Global MX-5 Cup Car Technical Service Bulletin #08-15-2017

Optional*: 2017 Global MX-5 Update: Bumper beam protrusions & foam

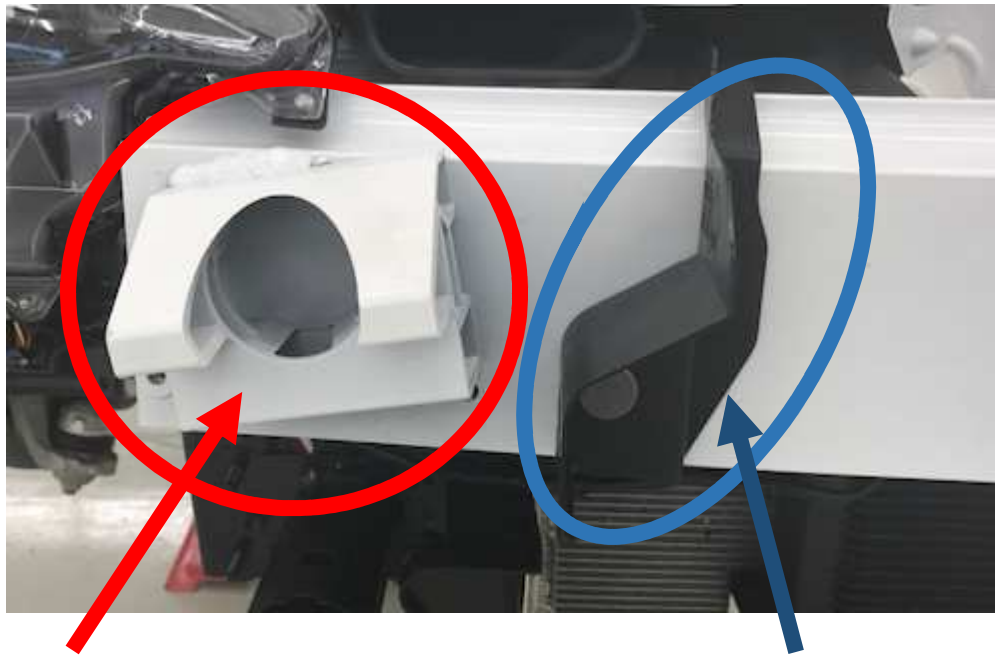
1. The front bumper beam (USA/CAN P/N NA1J-50-070D) may be substituted with MEXICO P/N N243-50-070D –OR– modified by removing both large protrusions (see pictures below). Also, you may also add a foam insert to the front of the bumper beam to help makeup that gap between the front fascia and the bumper beam.

1. Follow all Mazda service manual instructions for safety.
2. BUMPER BEAM
 - a. Remove the front fascia per the service manual instructions
 - i. Option A – Remove the US/CAN spec bumper beam and install the Mexico spec beam and ensure that the black plastic air guide (50-A20) be used on the new bumper beam. The air guide is a required part and **MUST** be in place.

- ii. Option B – Cut off the two protrusions that are ‘proud’ of the bumper beam so that the USA/CAN bumper beam resembles the Mexico bumper beam (see the diagram above). Ensure that the black plastic air guide (50-A20) be used on the modified bumper beam. The air guide is a required part and **MUST** be in place. (See below)

Right & Left protrusions that may be removed

Air Guide that **MUST** be in place

3. FOAM INSERT

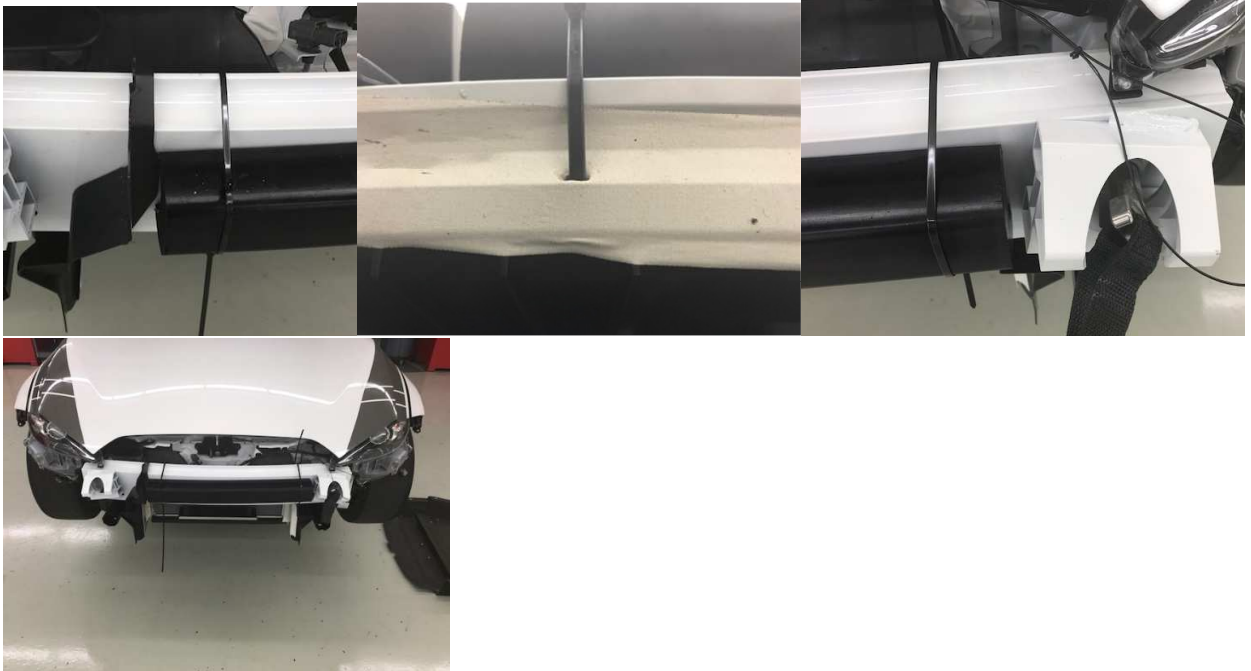
- a. You may install a single piece of FIA Type A roll bar padding, 30mm thick to fit 1 3/4" - 2" bar diameter (with trapezoidal profile) between the air guide and the tow hook. Use wire ties around the bumper beam and only cut the minimum size slit to pass the wire tie past the tape which is under the bumper beam. Please note that the picture below still has the protrusion around the tow hook, and once removed the foam may be installed up to the tow hook mounting hole.
